ANNEX B-1. DRAFT VALUE ENGINEERING REPORT

CENTRAL EVERGLADES PLANNING PROJECT FEASIBILITY PHASE

VALUE ENGINEERING STUDY REPORT

February 2013

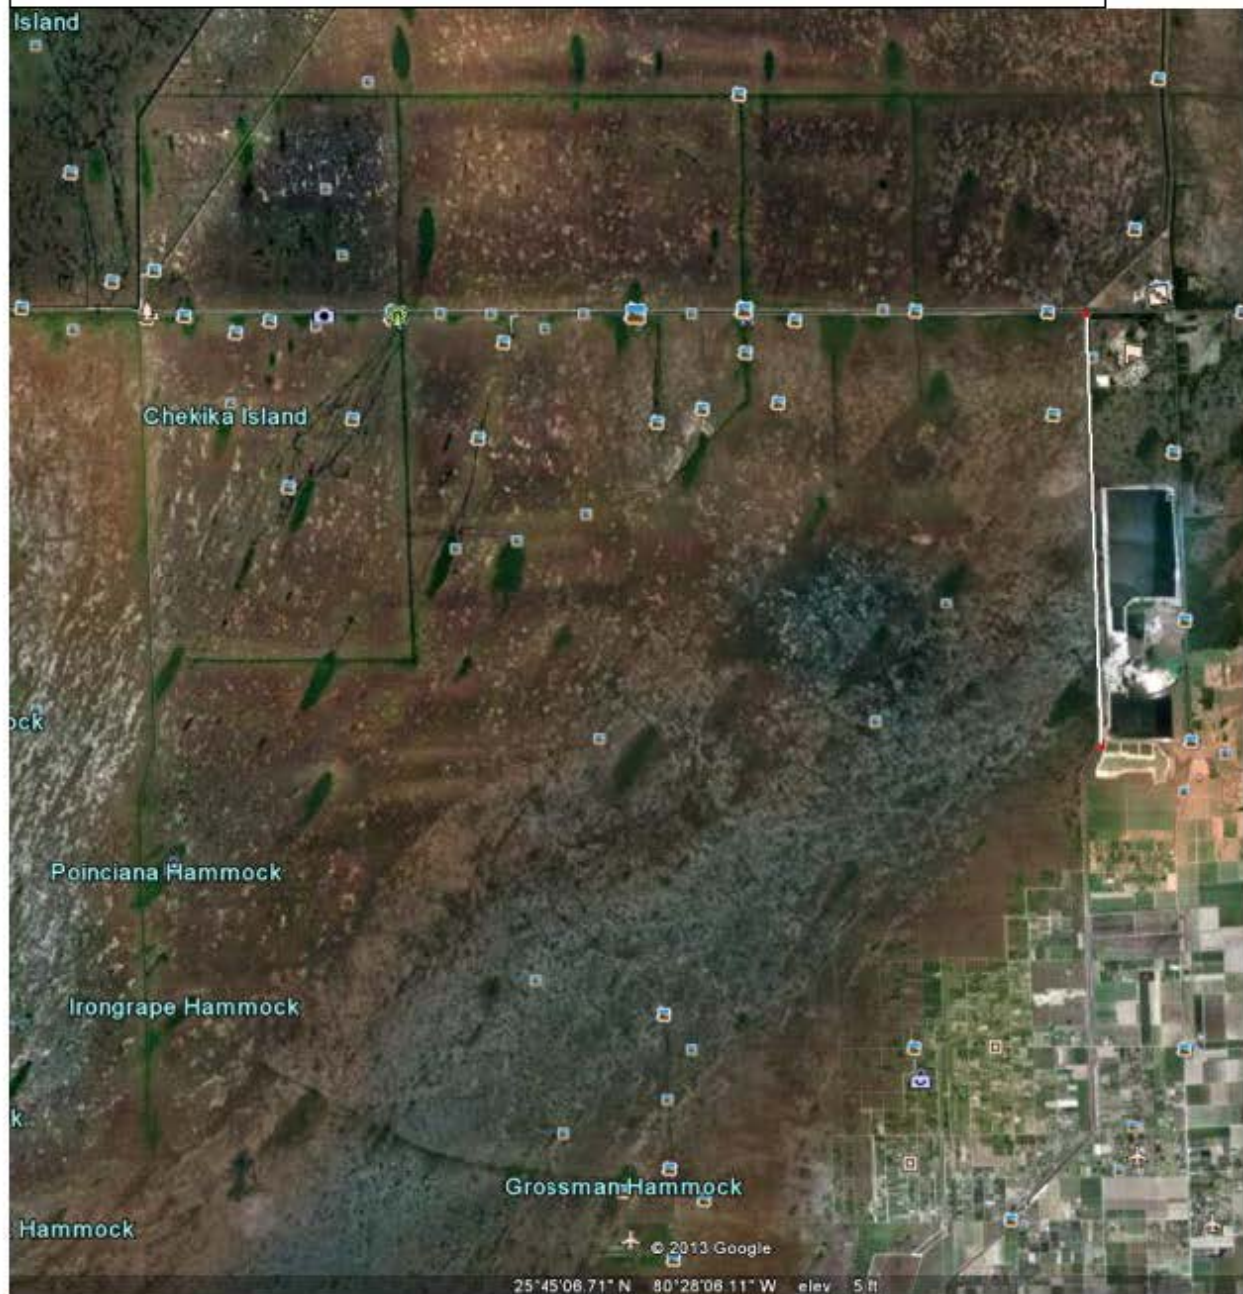
station currently planned at 1,000 cfs capacity. This option would call for the construction of the proposed adjacent canal seepage barrier cut-off wall and project purpose water level increase in the Everglades Park. The existing 500 cfs pump station will likely be capable of accommodating most if not all seepage flow and actual pumping needs can be measured (see above recommendation regarding station design flowrate determination – 750 cfs / 1,000 cfs). Note that initial hydration of the Park can be initially controlled until such that pump station capacity is not exceeded.

Implementation of extending service of the temporary station appears to be difficult. Difficulties include, but may not be limited to:

- Expiration of current federal authorization and funding for operation and maintenance
- Ownership and responsibility
- Current litigation regarding discharge water quality (issue for permanent station as well but this option would require faster resolution)
- Physical rehabilitation of the station to facilitate continued use

Given the potential cost savings and advancement of some project benefits that this option would produce, addressing the above issues appears to warrant consideration.

Preliminary disposition: Address recommendation in current plan development, project design phase and in development of the Adaptive Management Plan.

Alternative D13R
Bird Drive Basin and L-31N Seepage Management
Component Map 7

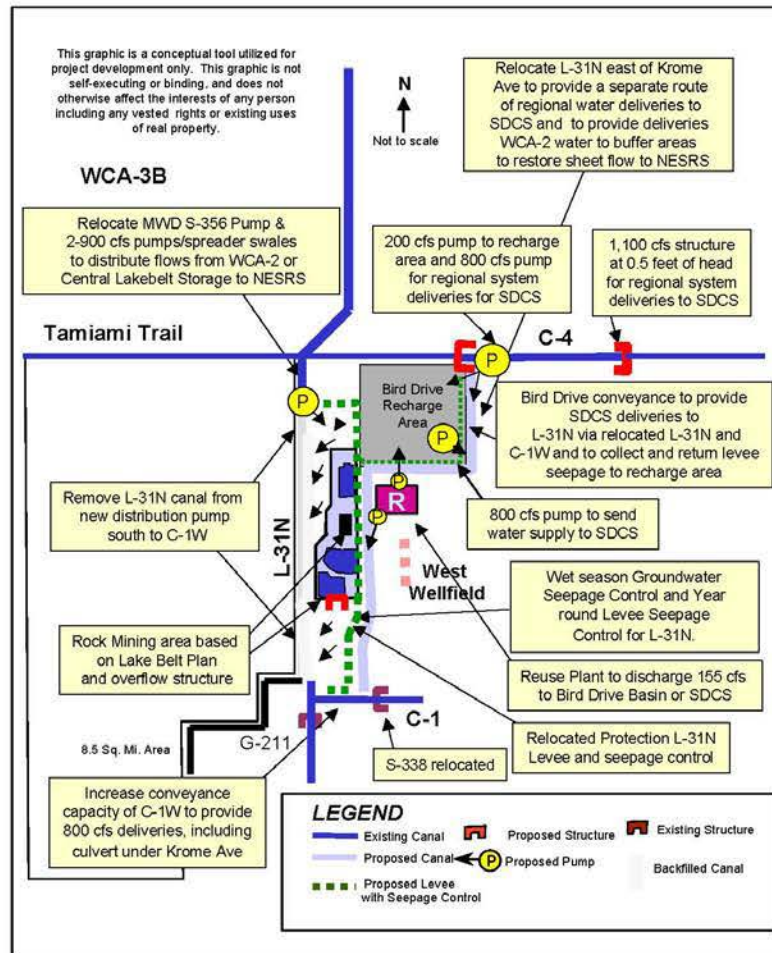
(RECOMMENDATION #54)Y-5 Change the location L31N Seepage Management Pilot Project (SMPP) to the location which was the original location contained in the authorized decision document; use CEPP to increase the 902 Limit for L31N SMPP and install the L31N SMPP to remove project uncertainties - L-31N Seepage Management – Pilot Project is an authorized component in the Central and Southern Florida Project, Comprehensive Review Study, Final Integrated Feasibility Report and Programmatic Environmental Impact Statement.

- The location of the pilot be returned to the original location as depicted on the below page excerpt from the study;
- CEPP be used to update the 902 limit for the pilot test and
- Implement the pilot test early in the project implementation phase to remove and define uncertainties.

As described in the restudy, the purpose of this feature is to reduce seepage flow across L-31N adjacent to Everglades National Park via a levee cutoff wall. Additionally, the feature was designed to reduce groundwater flows during the wet season by capturing groundwater flows with a series of groundwater wells adjacent to L-31N, then back-pumping those flows to Everglades National Park. The pilot project is necessary to determine the appropriate technology to control seepage from Everglades National Park. The pilot project will also provide necessary information to determine the appropriate amount of wet season groundwater flow to return that will minimize potential impacts to Miami-Dade County's West Wellfield and freshwater flows to Biscayne Bay.

Preliminary disposition: Address recommendation in current plan development.

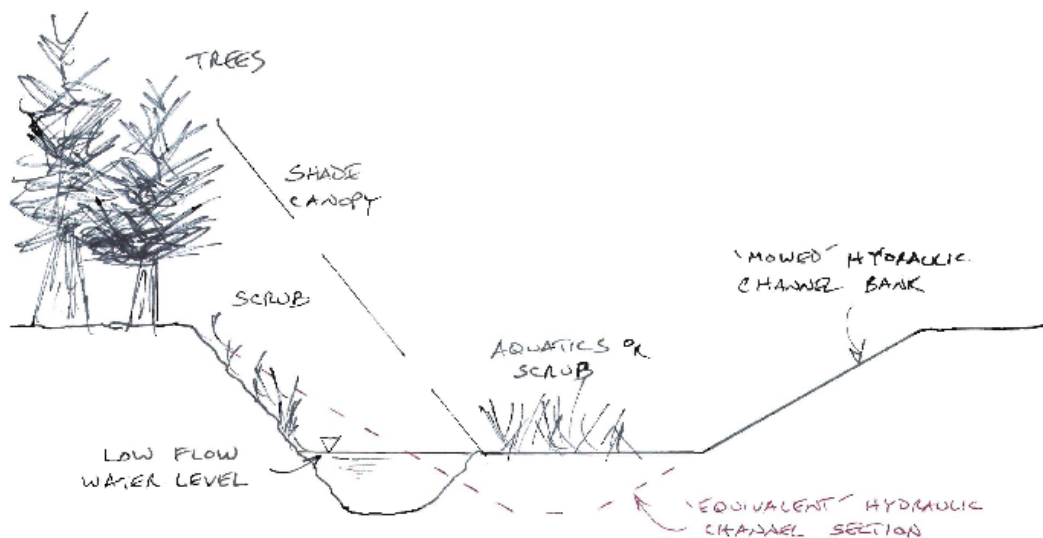
Y-6 Investigate alternative seepage barrier cutoff wall means (such as vinyl sheet pile) -

Completed work on L-31N (L30) Seepage Barrier Pilot Project should be evaluated for possible cost-effective alternatives to the currently planned seepage cut-off wall in this reach.

Preliminary disposition: Address recommendation in project design phase.

2004 Northern WCA 3A Veg

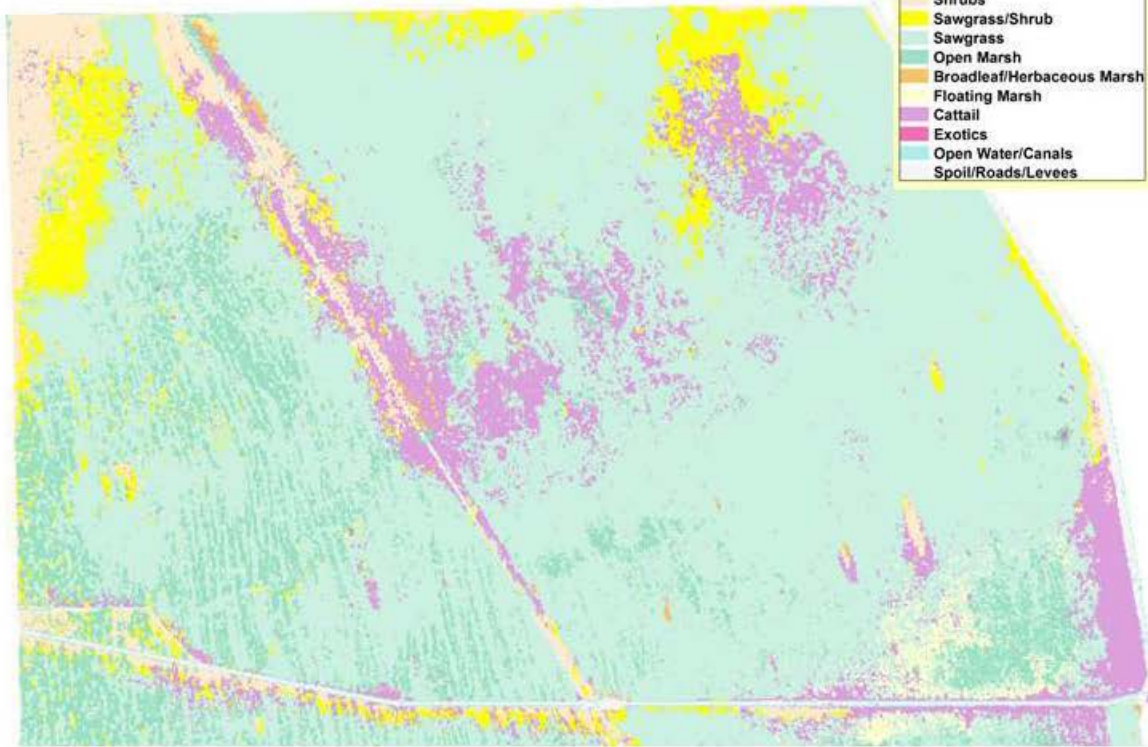
GC-2 Coordinate vegetation management to achieve multiple objectives - Much of the vegetation south of L-4 levee are upland species due to the drying out of Northern Water Conservation Area 3A (WCA 3A). These woody species are likely to persist and may require specific vegetation management activities to facilitate transition of the landscape to more wetland type vegetation (e.g., sawgrass). Cattail and Willow expansion may be an issue and needs to be properly managed to avoid further degradation and complication in achieving a ridge and slough landscape south of the L4 spreader canal, as well as getting water out of the canal for flood control needs due to flow resistant vegetation. In addition, vegetation management will likely be needed during construction of the L4 spreader canal to remove nuisance and exotic species, as well as potentially create vegetation pockets to help facilitate flow of water to aid recreation of sloughs upon entry into marsh. There are likely opportunities to strategically coordinate multiple vegetation management objectives (e.g., construction, nuisance, and restoration enhancement) to most cost effectively implement vegetation management activities.

Timing and nature of each vegetation management activity would need to be discussed and coordinated amongst engineering design, construction, exotics removal, and ecological/adaptive management subteam to determine what vegetation management efforts are needed when and how they can be best be implemented. The Invasive and Native Nuisance Species Management Plan (INNSMP) would address responsibilities and timing. The INNSMP is a living document. It would be updated/revised as surveys are done and treatment/removals conducted, and include proposed schedules of surveys. During O&M, the structures would be monitored by the responsible operations entity. Areas of claimed benefits outside of the structures would be monitored by the project (PLMP, RECOVER, or other). Close coordination among agencies would be required for such a program to succeed. Areas needed to be treated most times can be covered by existing services contracts that the USACE/SFWMD already has in place.

Preliminary disposition: Address recommendation in development of Adaptive Management Plan.
